**DOCUMENT 00 91 02  
ADDENDUM NO. 2**

PROJECT: 2024 Anthony, Hopper and Kahla MS Renovations

FROM: Carolina Weitzman, A.I.A.  
Natex Corporation Architects  
447 Heights Blvd, Houston, TX 77007

**TE11.12**

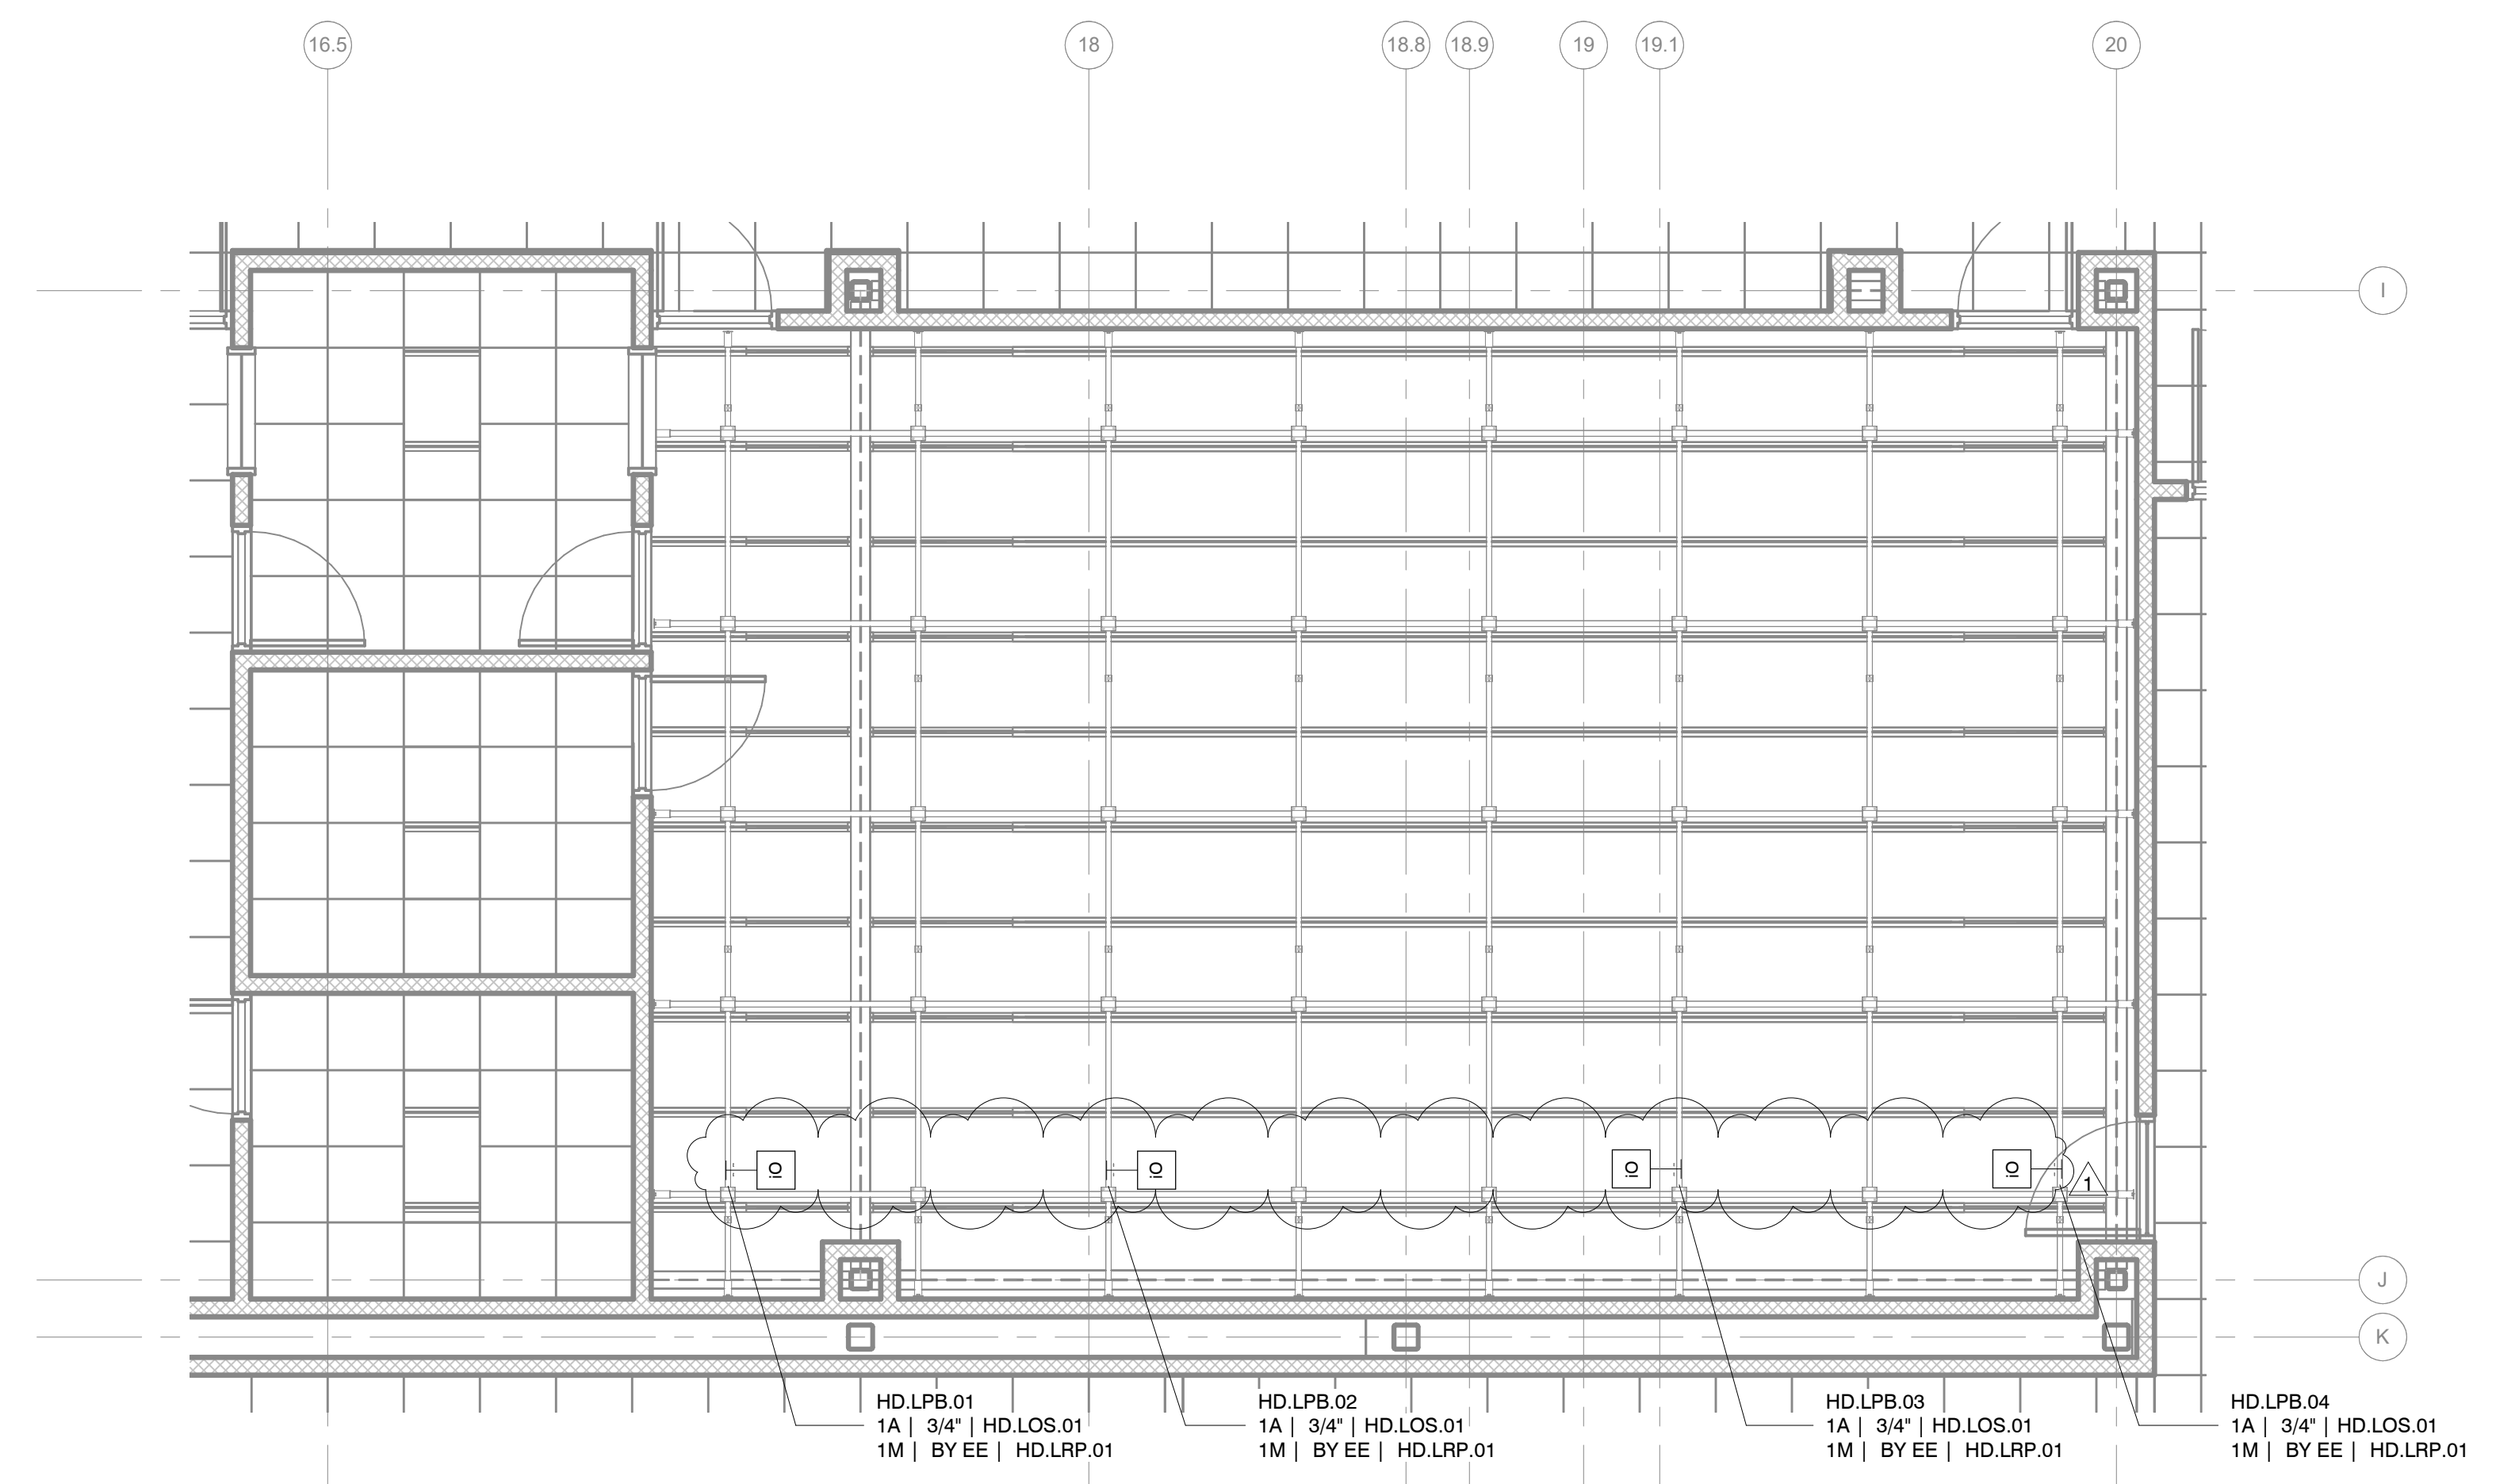
73. TE11.12 TE – 1<sup>st</sup> FLOOR CEILING PLAN DRAMA 1221
  - a. Revised pipe spacing from 4' x 4' to 5' x 5'

**M0.01**

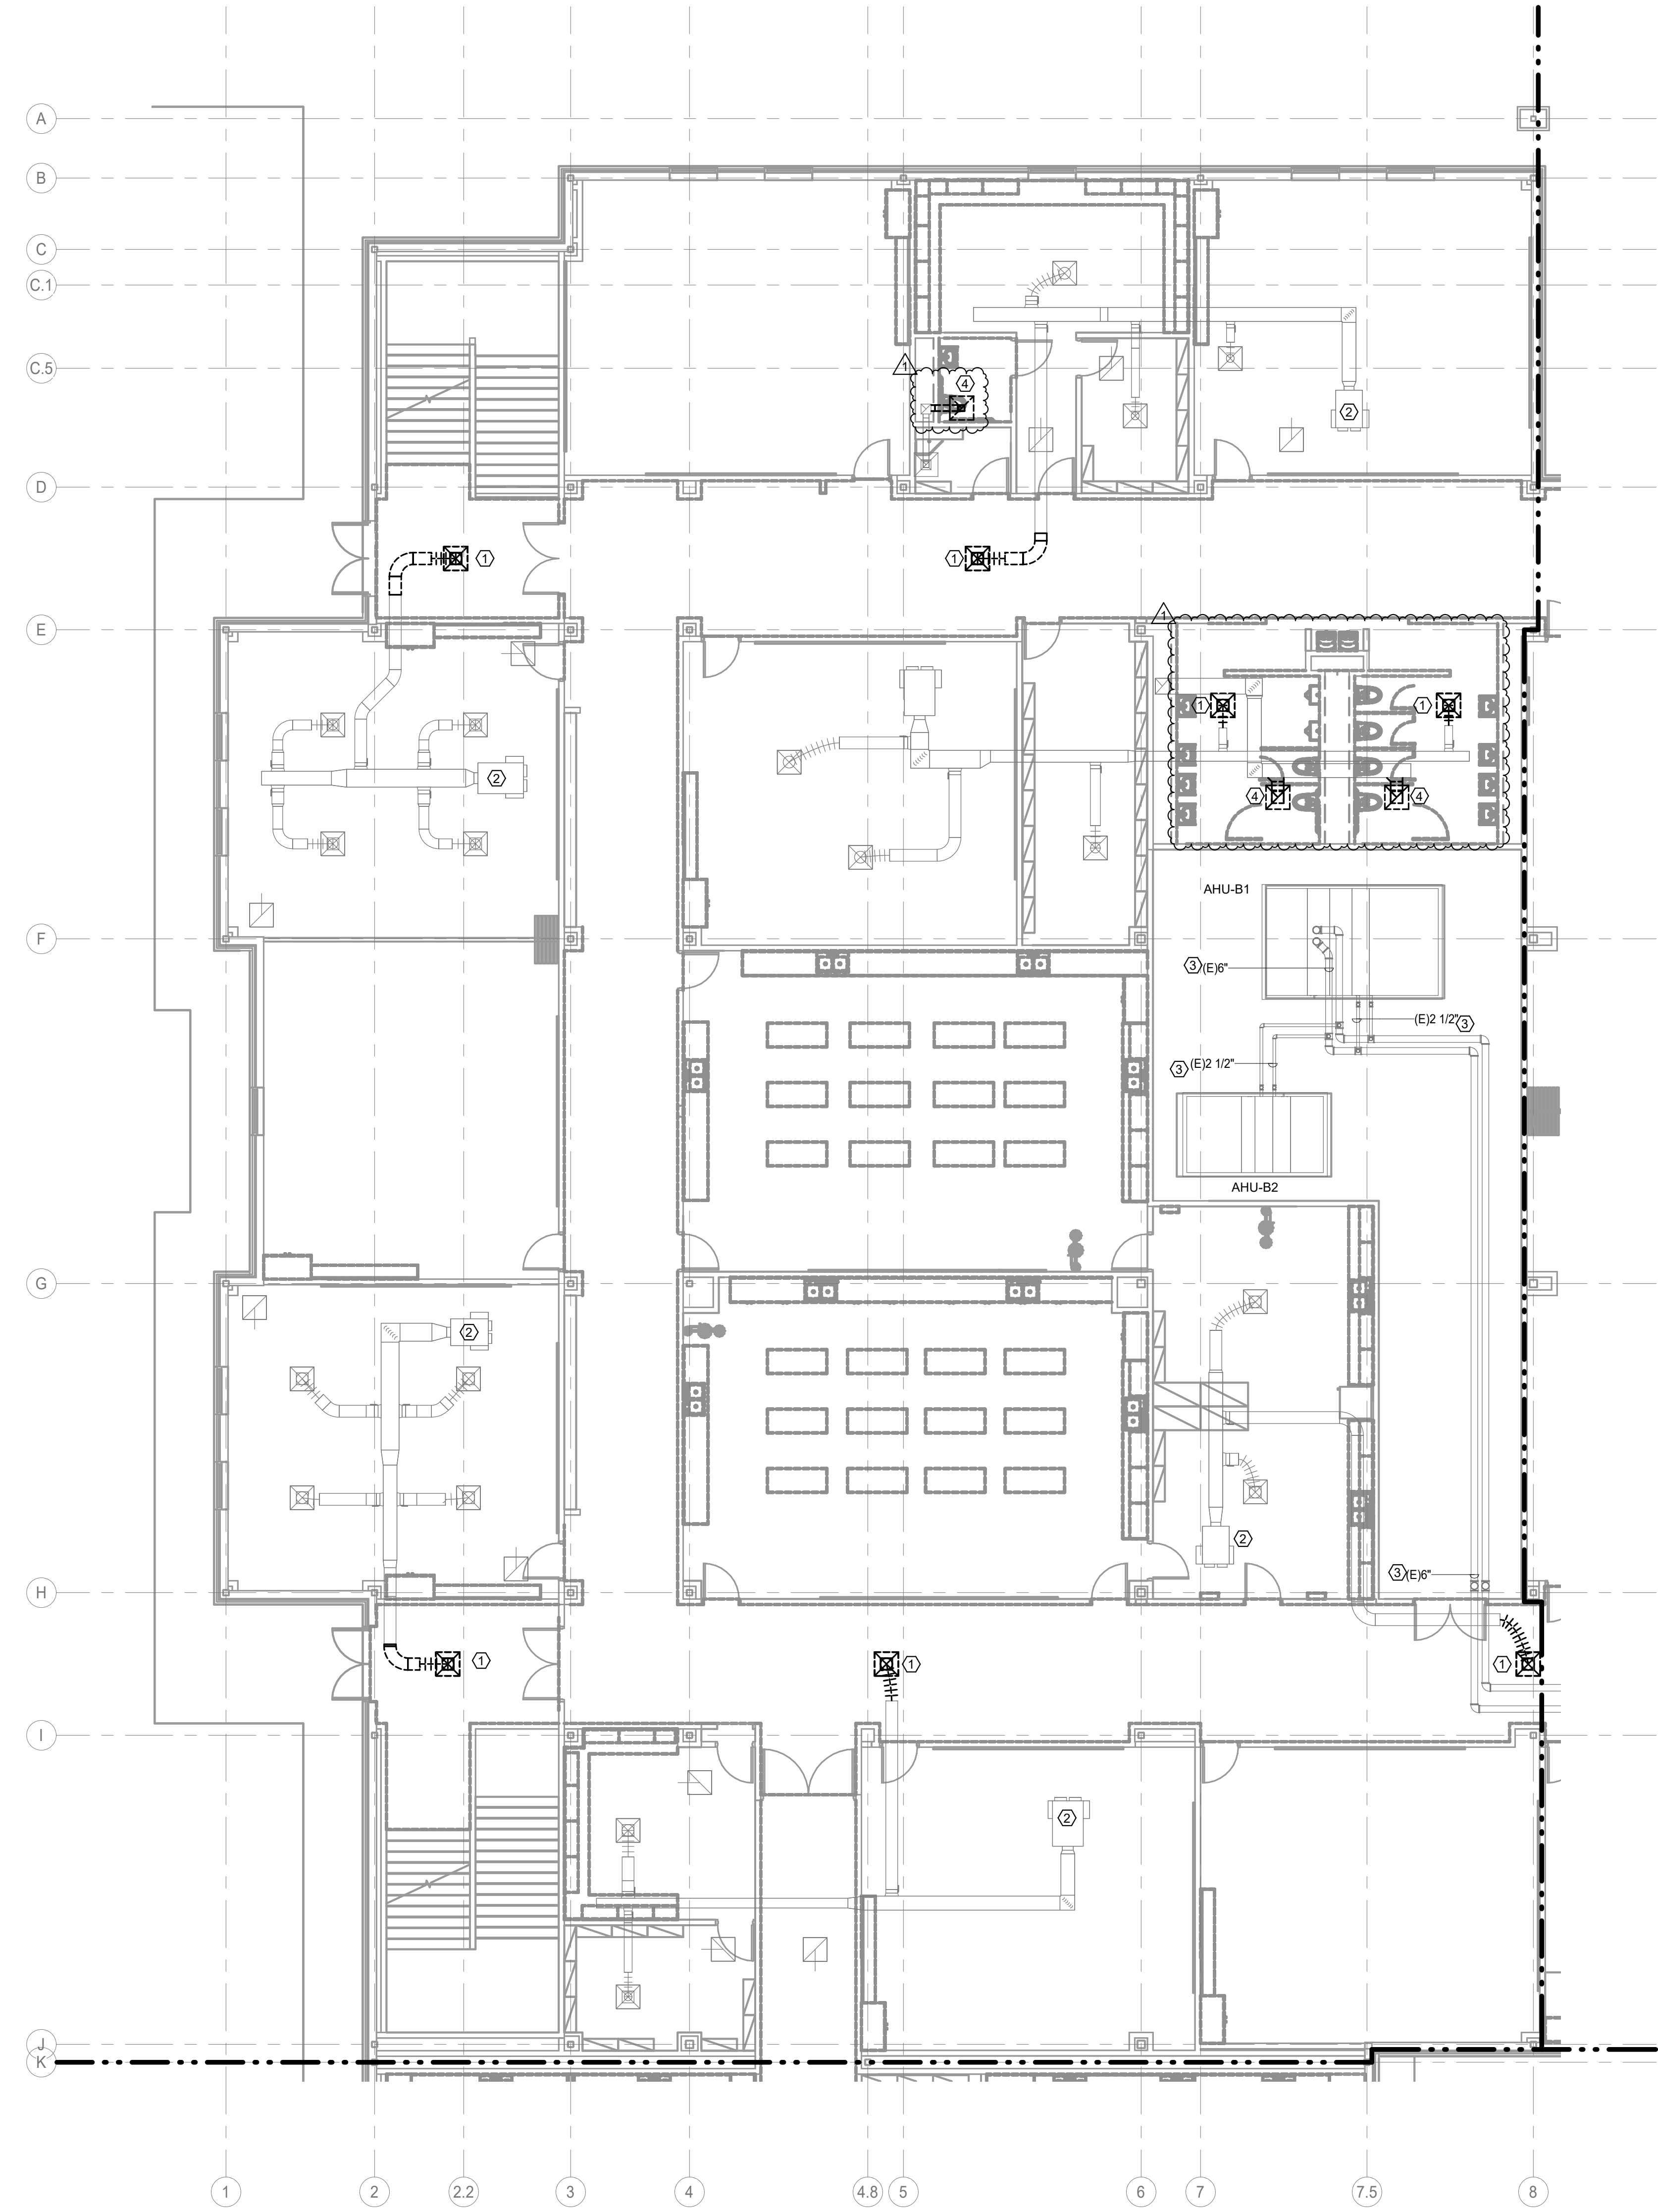
27. M0.01 – MECHANICAL DEMOLITION FIRST FLOOR PLAN – AREA A
  - a. Added air device replacement scope in restrooms.

**M0.10**

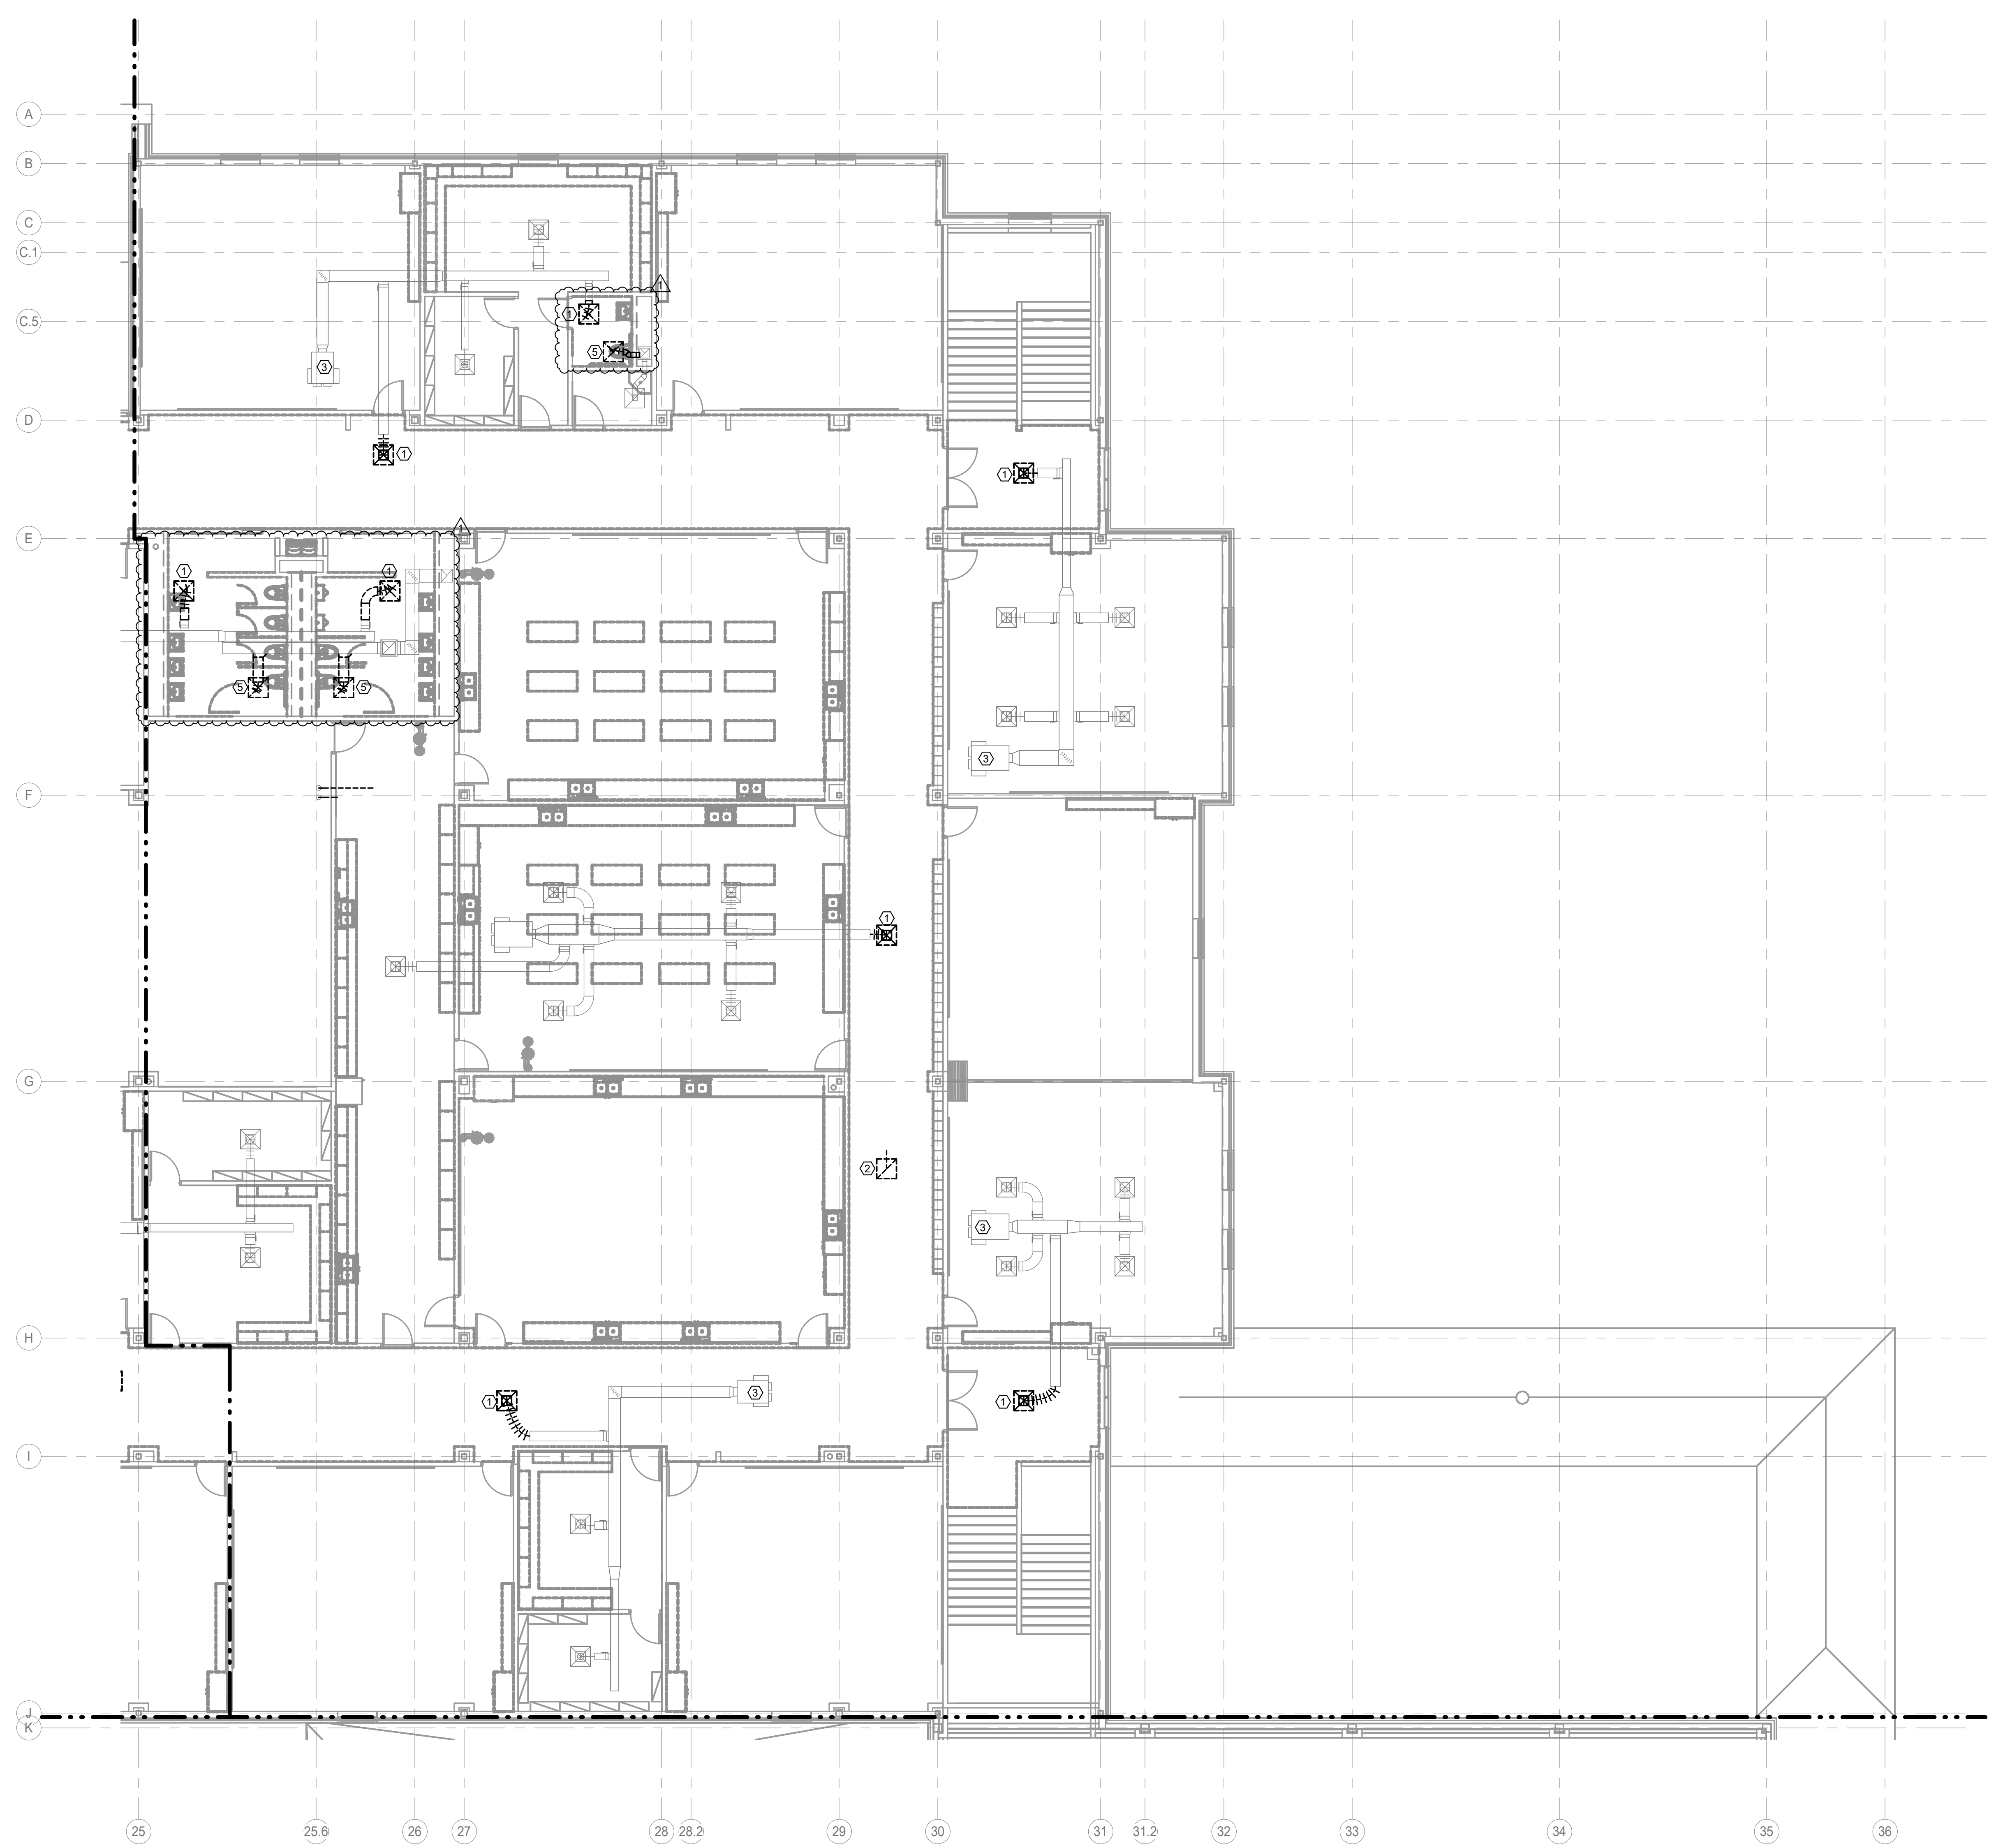
32. M0.10 - MECHANICAL DEMOLITION SECOND FLOOR PLAN – AREA B
  - a. Added air device replacement scope in restrooms.
